PLANNING & ZONING BOARD AGENDA

Wednesday, December 10, 2025

**PLANNING & ZONING BOARD
AGENDA ITEM 6A**

REQUEST: **CONTINTUED PUBLIC HEARING:** Peltier Ponds
1. Comprehensive Plan Amendment
2. Rezoning
3. PUD Preliminary Plan
4. Preliminary Plat

CAD FILE
24205pp1.dwg
PROJECT NO.
24205-00
C2.0

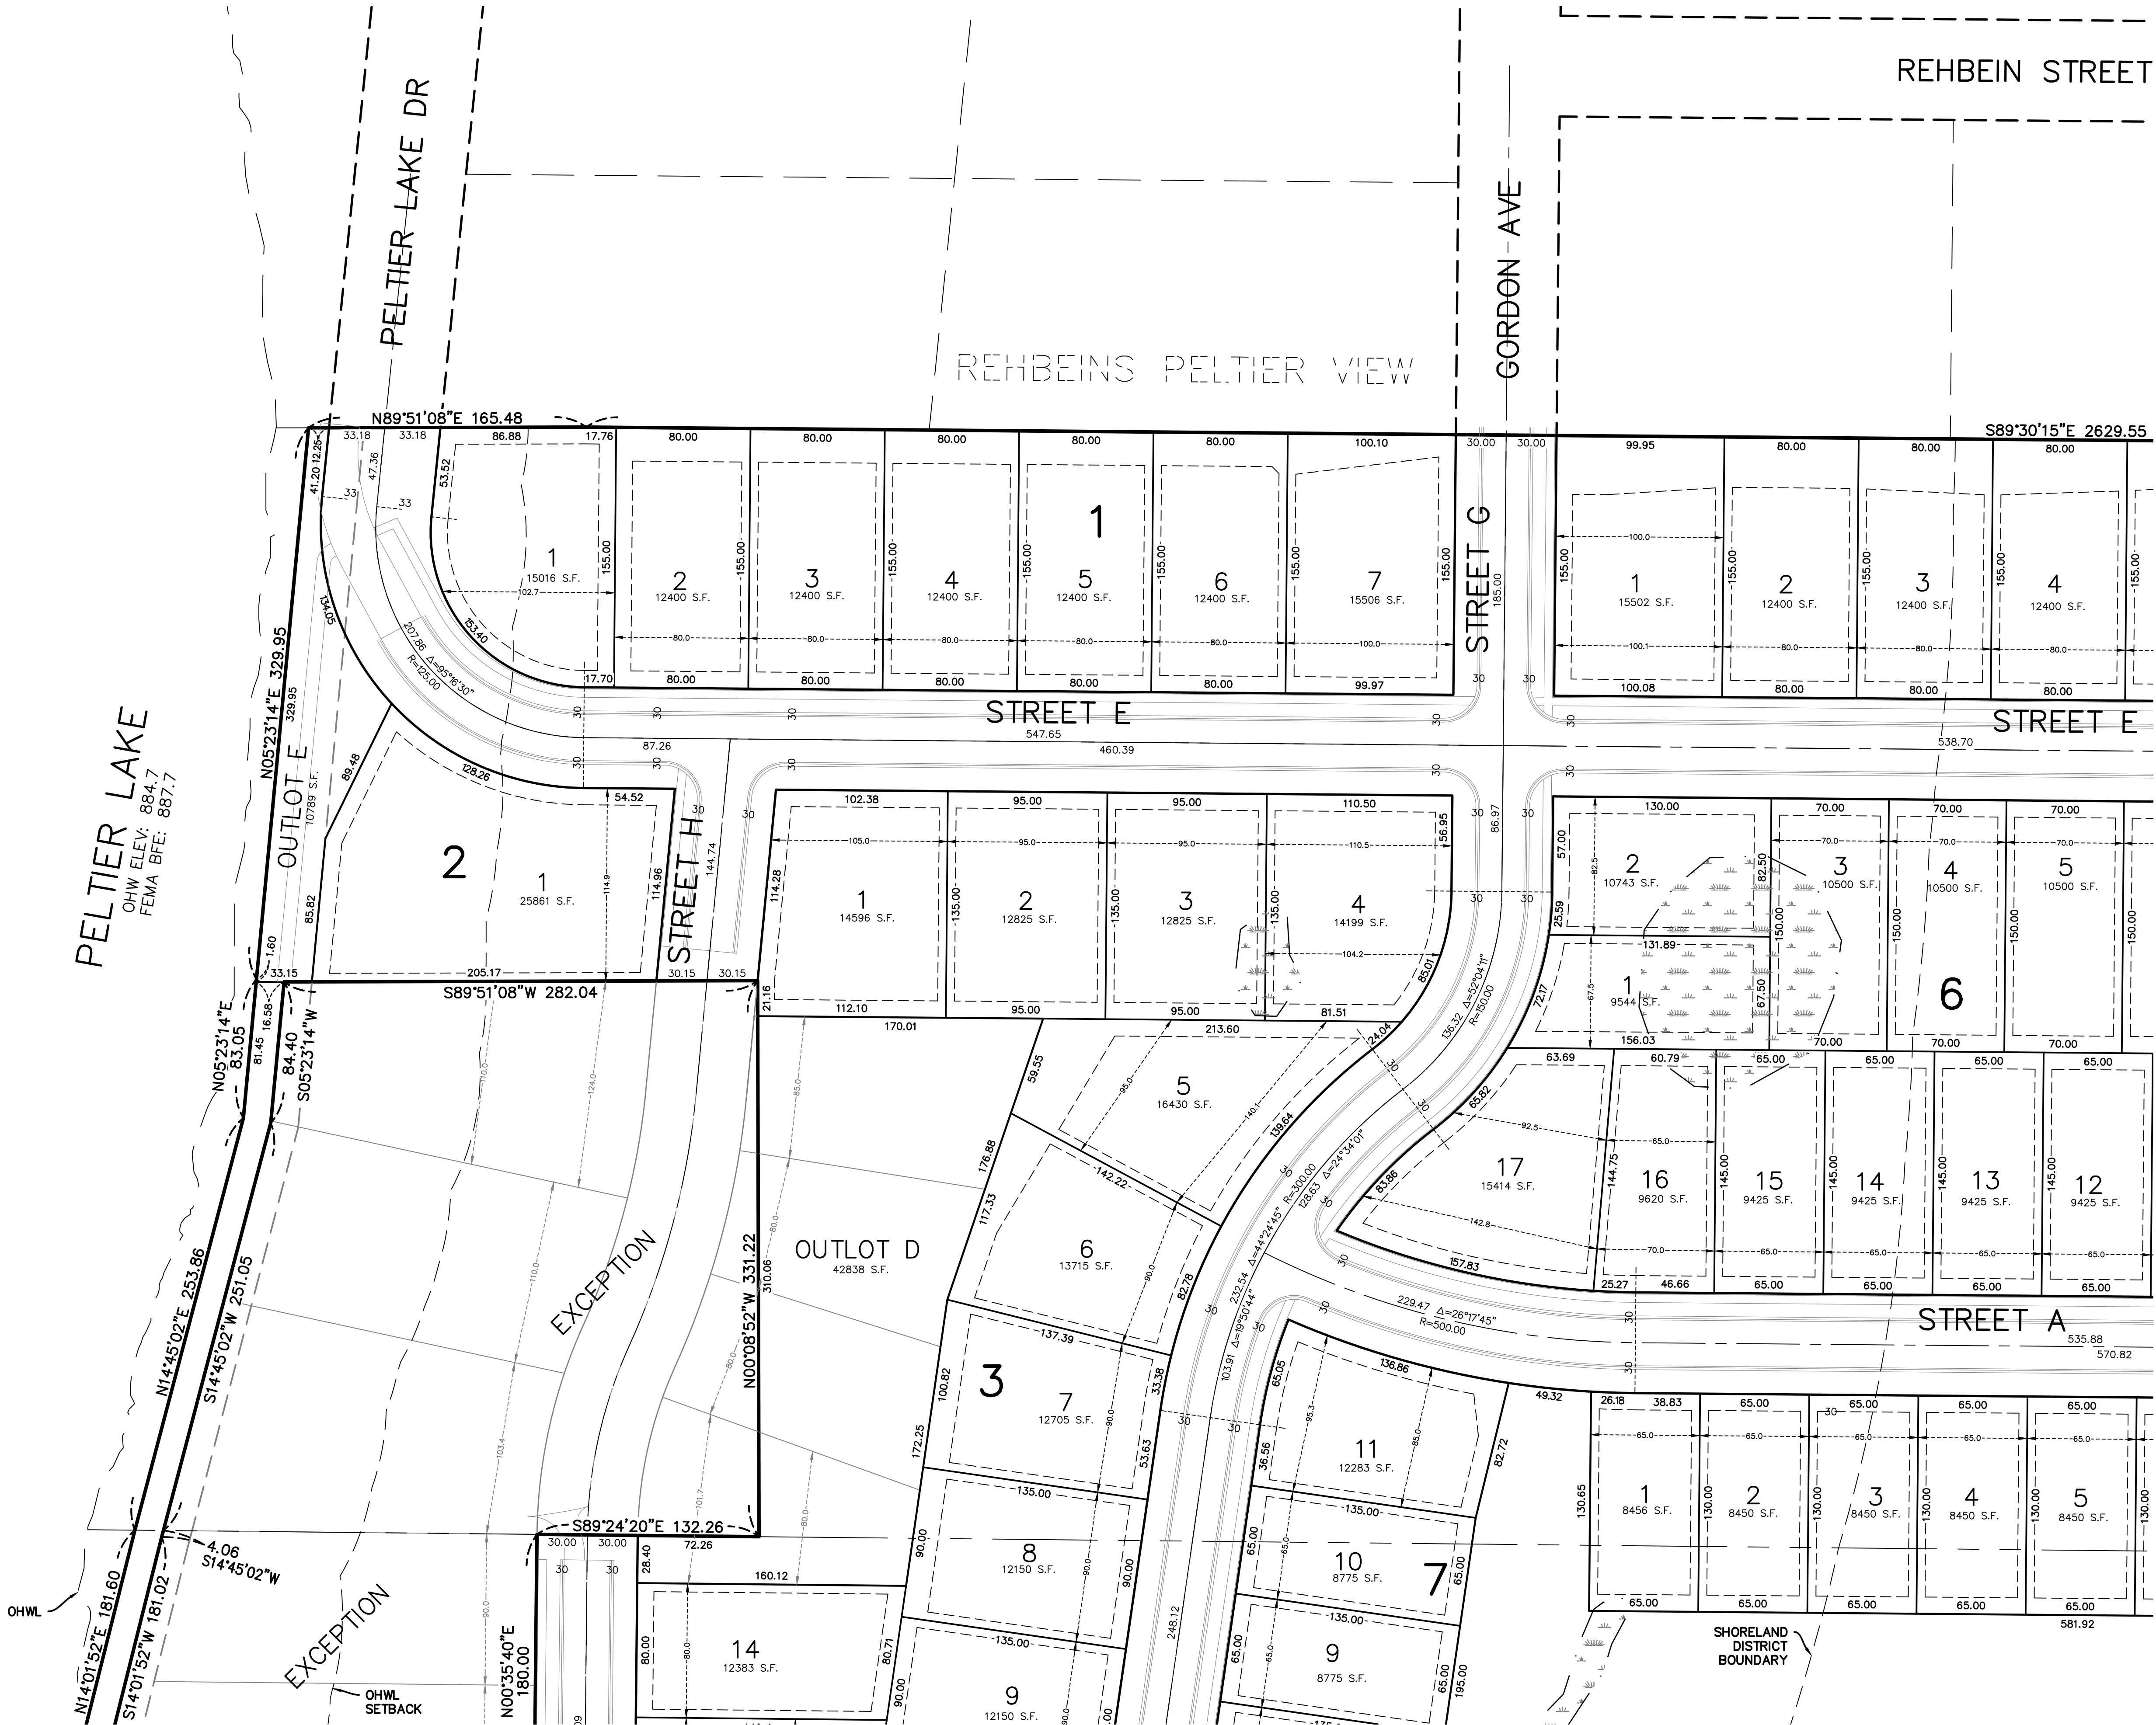
The proposed development provides a mix of residential lots and blocks. Outlots contain wetlands, buffers, stormwater ponds etc. Per Sheet C2.0, Preliminary Plat:

1. During PUD Concept Plan review, staff noted the property owner's lot at 7566 Peltier Lake Drive should be incorporated into the plat. This was not done. Outlot D is proposed to be sold to the property owner for future development. Staff notes future development will need to meet all land use, density, zoning, subdivision, shoreland, etc. ordinances.

LEIBEL SITE
YIELD PLAN
FOR
LENNAR

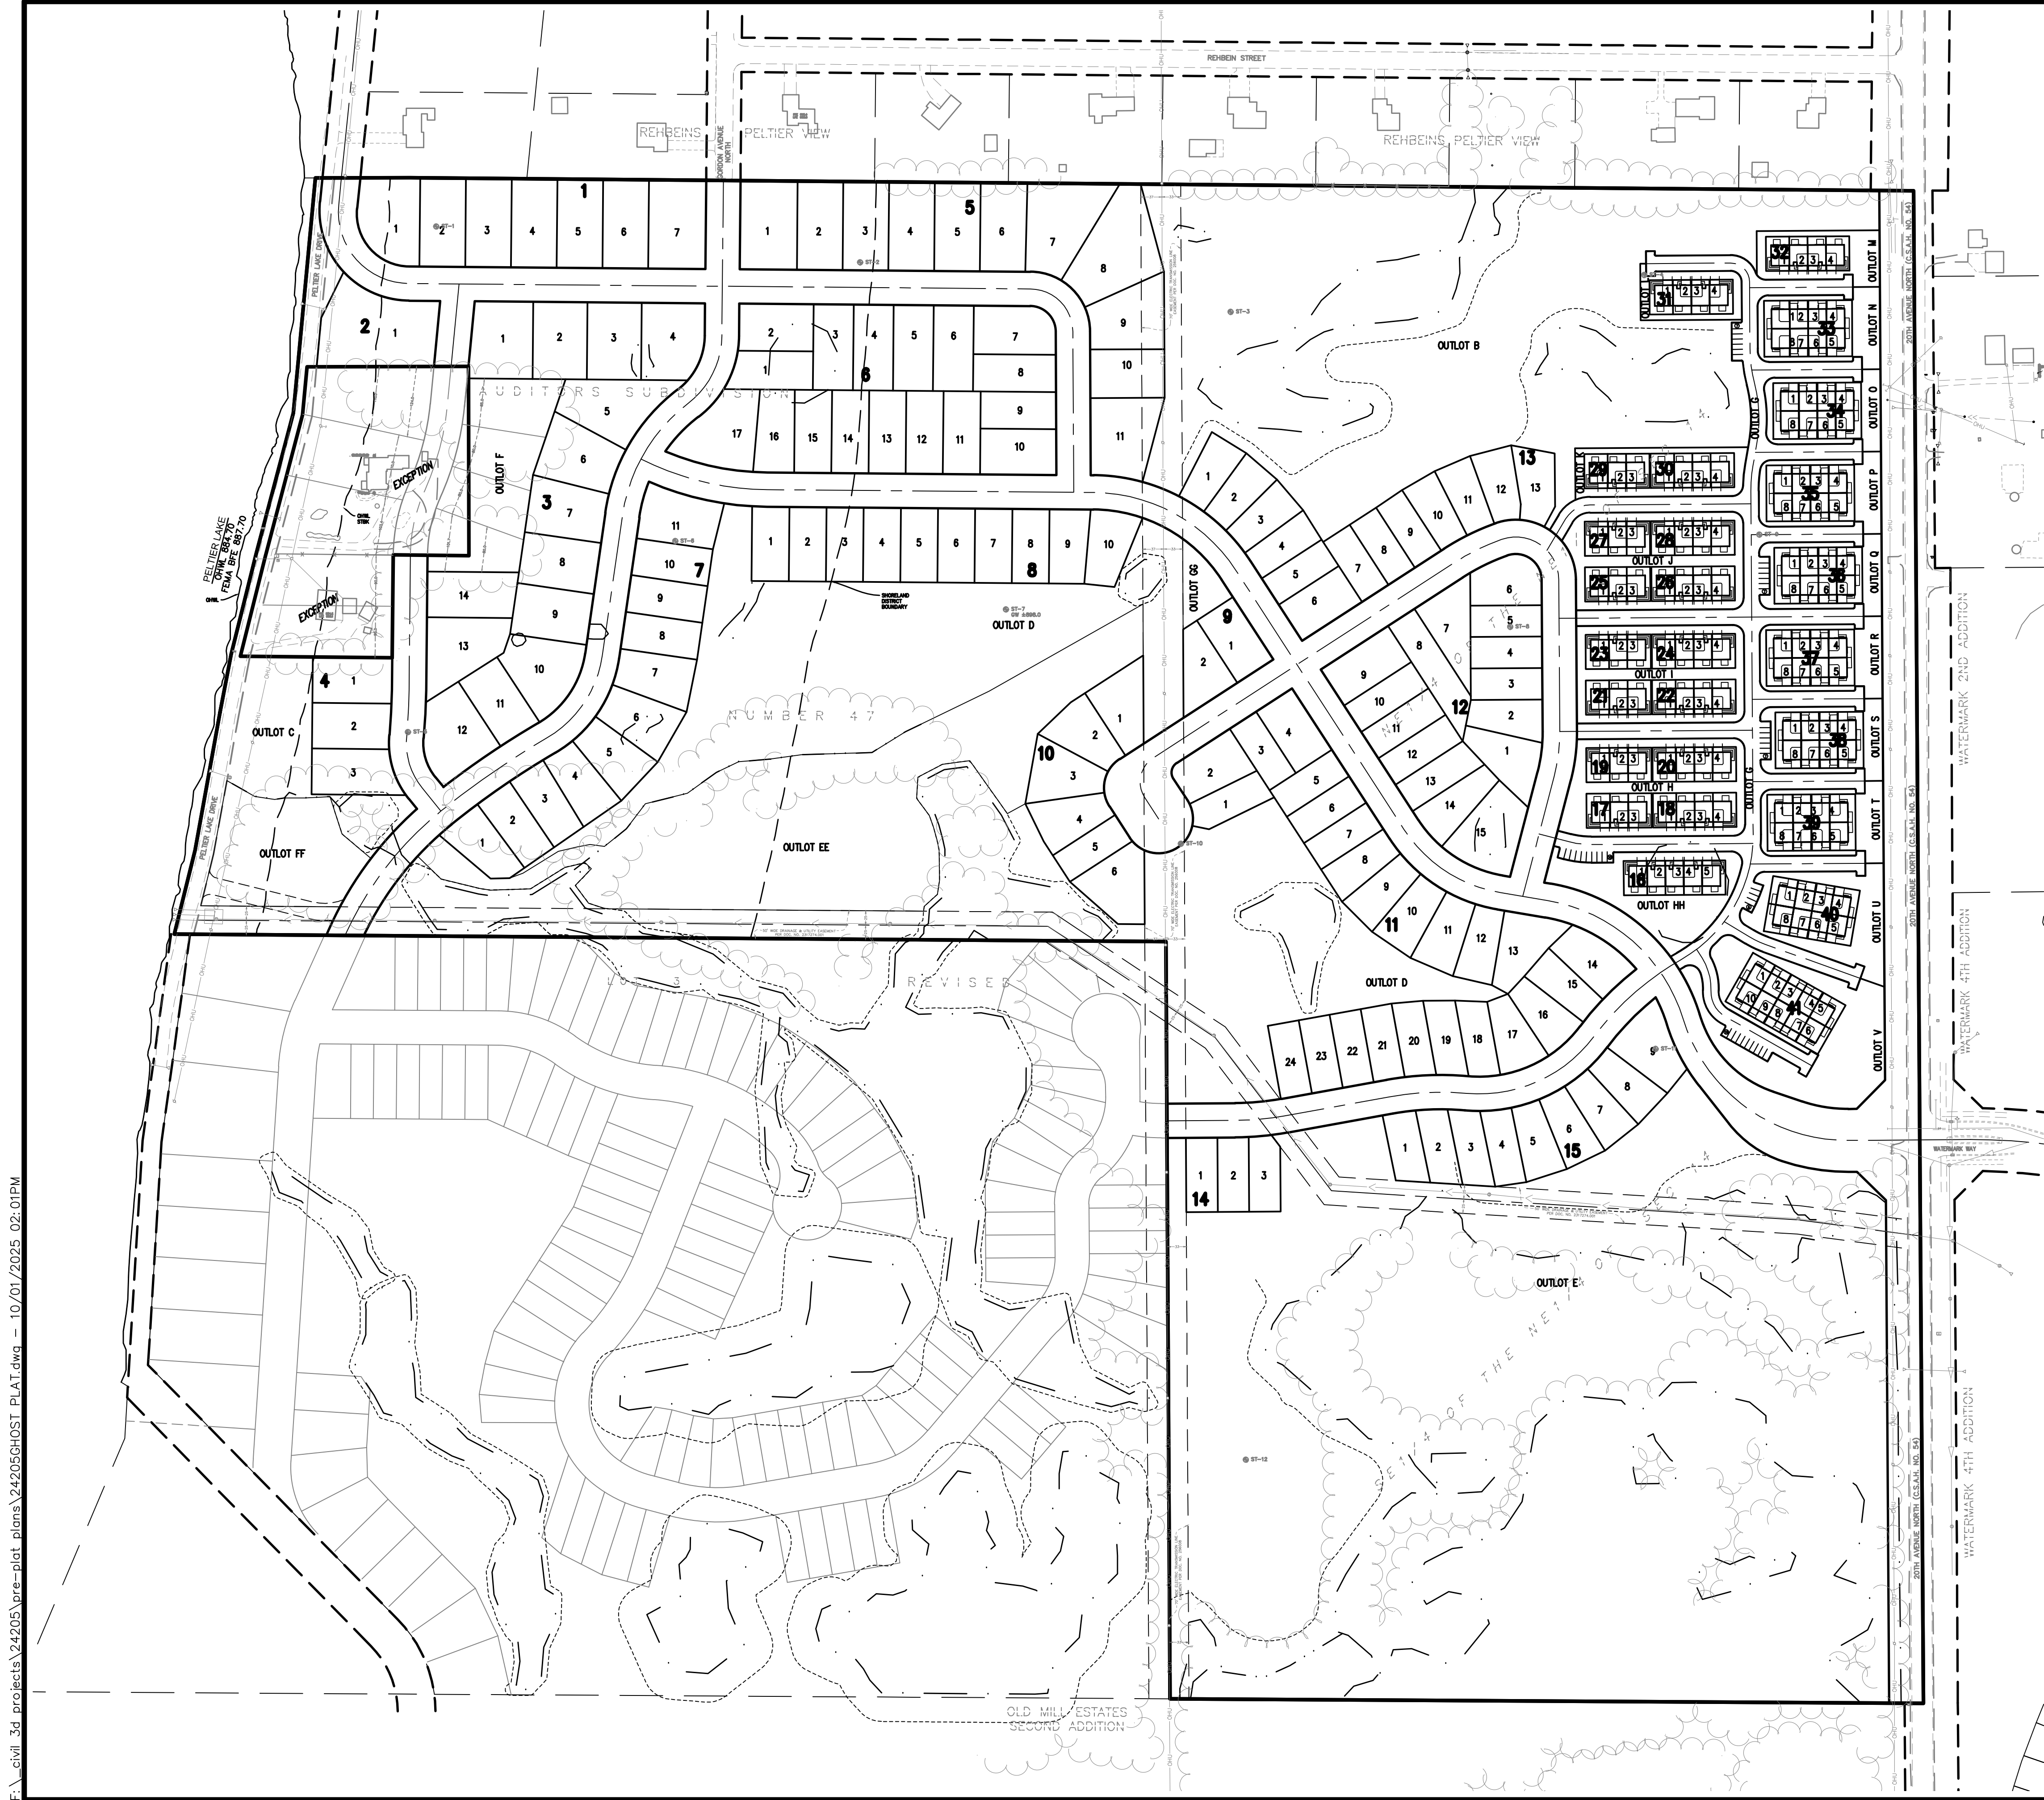
As required per City Code Section 1001.041(2)(a)7, the applicant submitted the attached yield plan. The yield plan shows the maximum number of dwelling units that would be permitted given the minimum lot size and lot widths for conventional subdivisions and other requirements of the Lino Lakes Zoning and Subdivision Chapters.

The submitted yield plan indicates single family lots, townhomes and an apartment totaling 332 housing units.

** Staff supports PUD flexibility for the 65ft wide single family lots as long as the lot depth is 135ft and shoreland lot size requirements are met.

A5.102

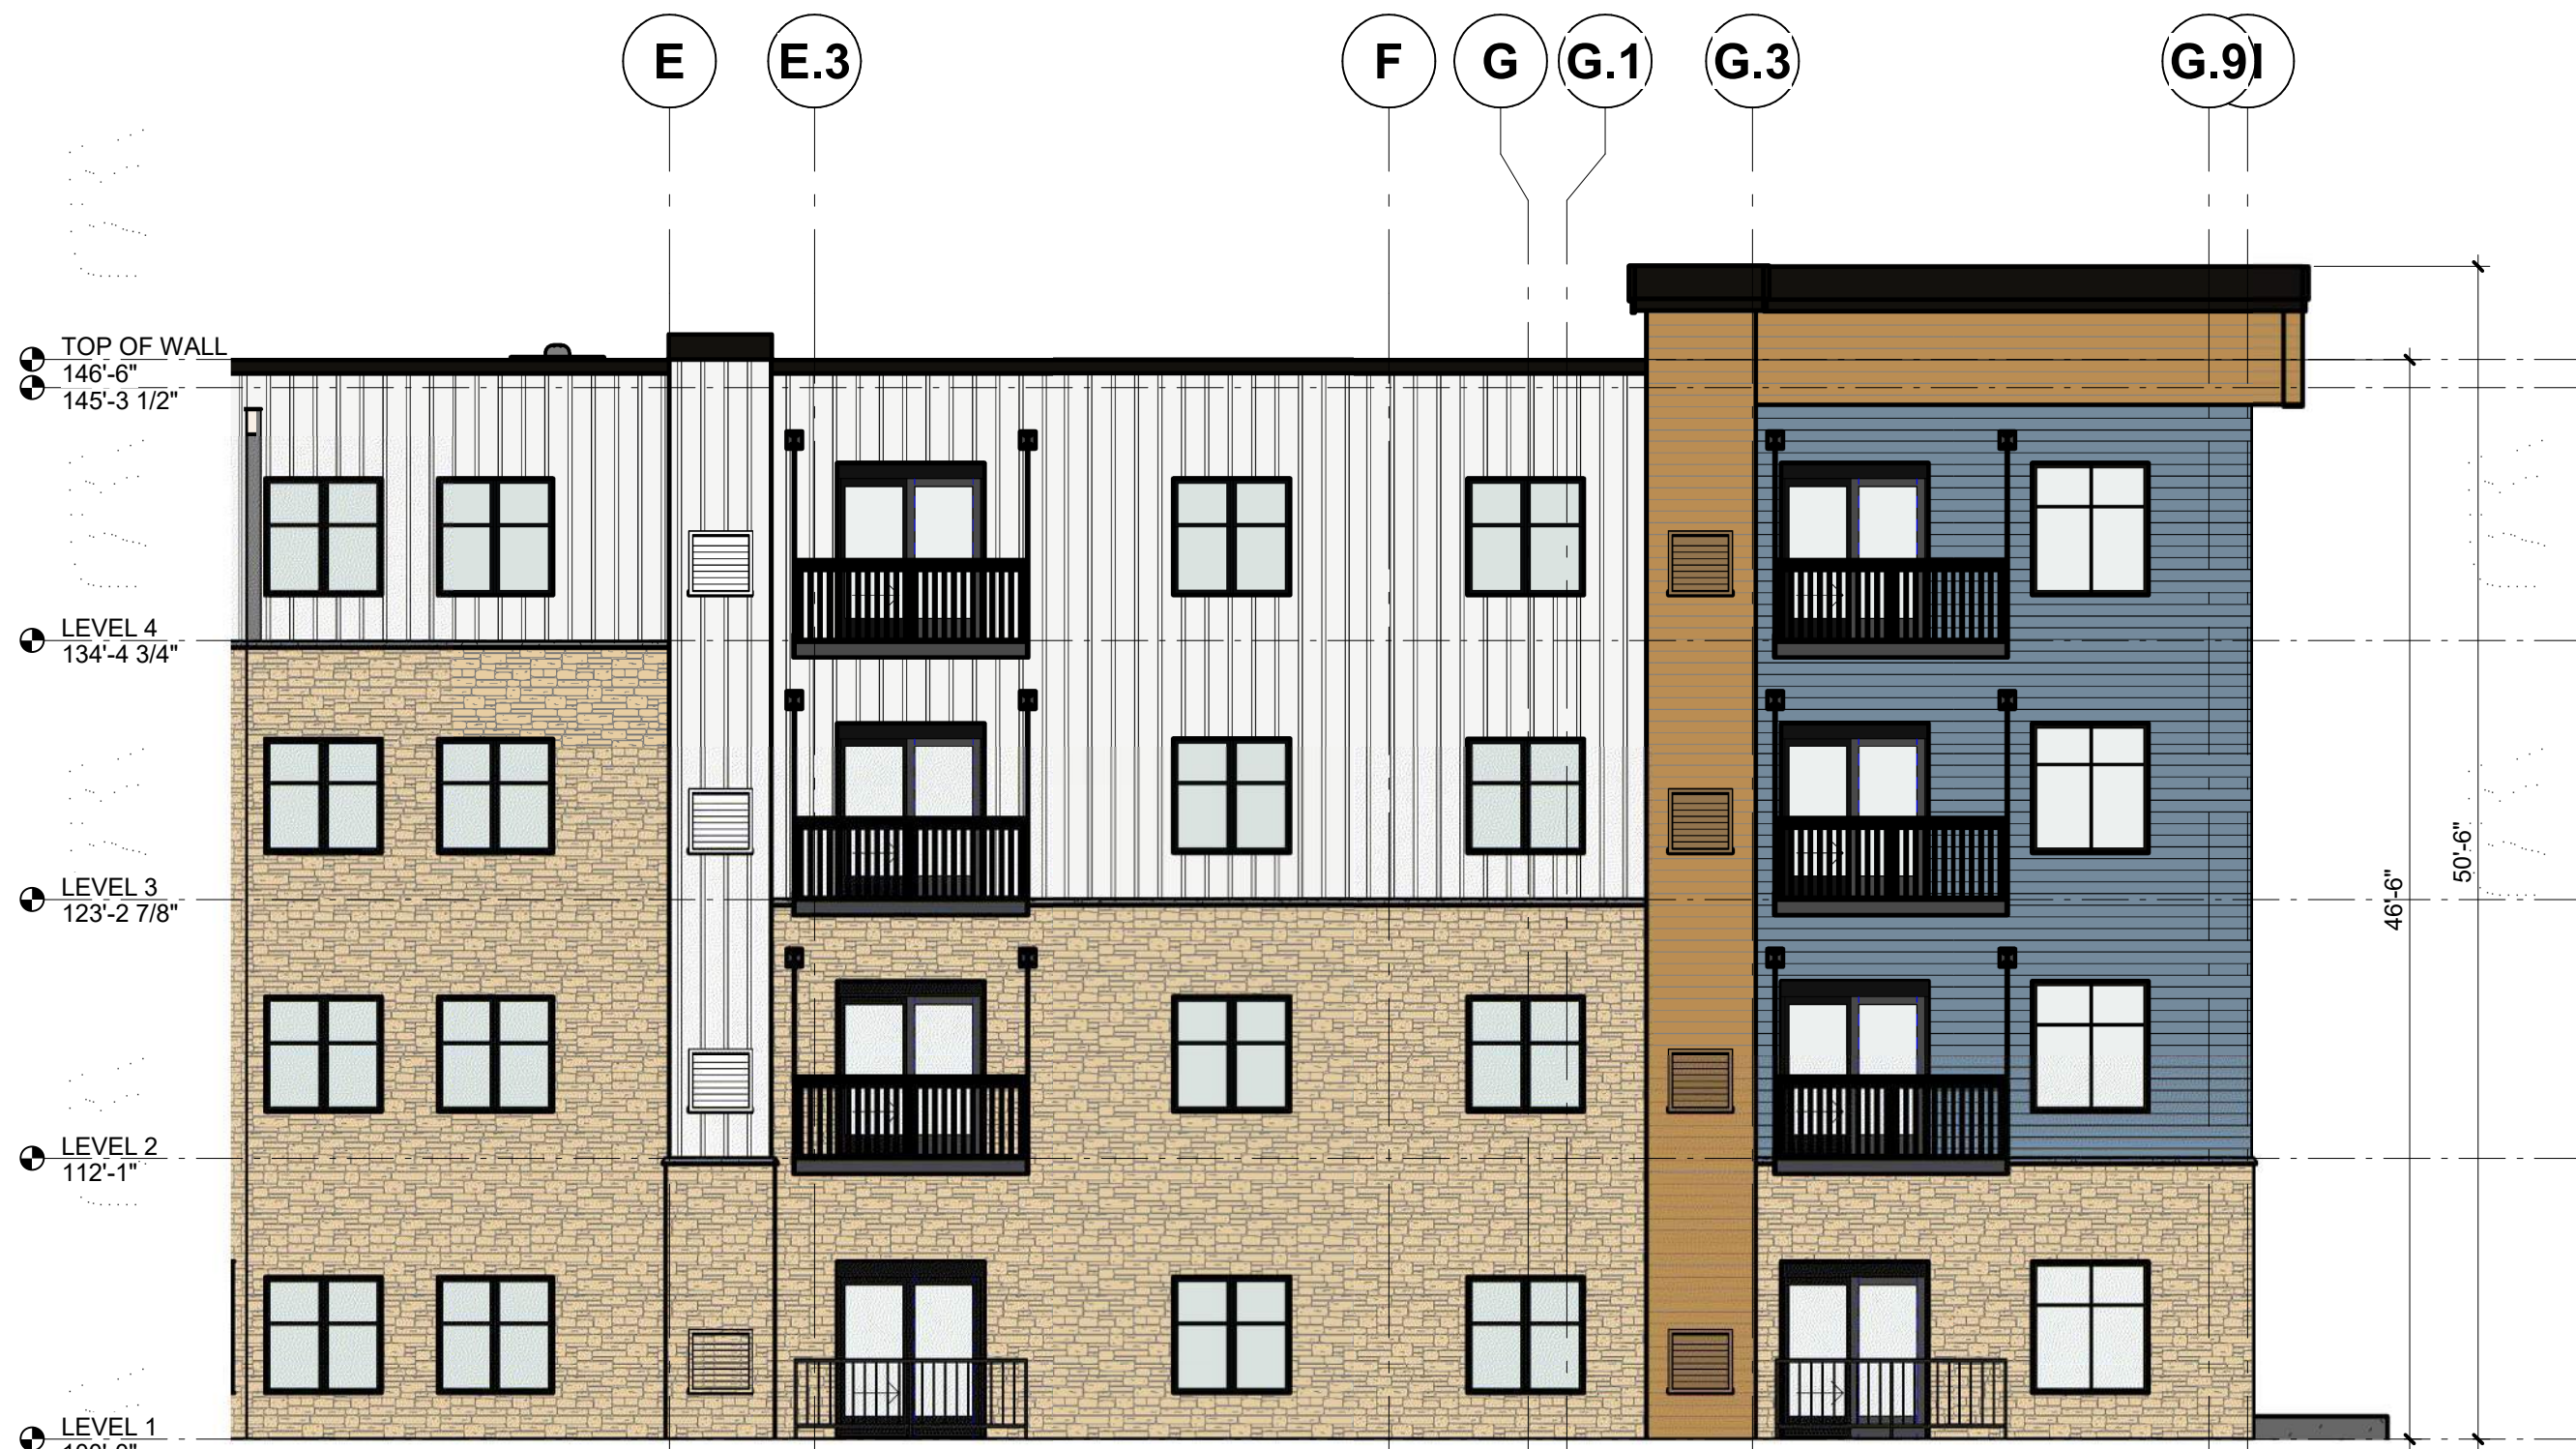
1. City Engineer Memo dated December 3, 2025
2. Environmental Memo dated November 26, 2025
3. All plan sheets shall have applicable revision date.
4. Sheet A5.103, Exterior Elevations:
 - a. Under Exterior Elevation Materials, should A13/B1 be A5.105?
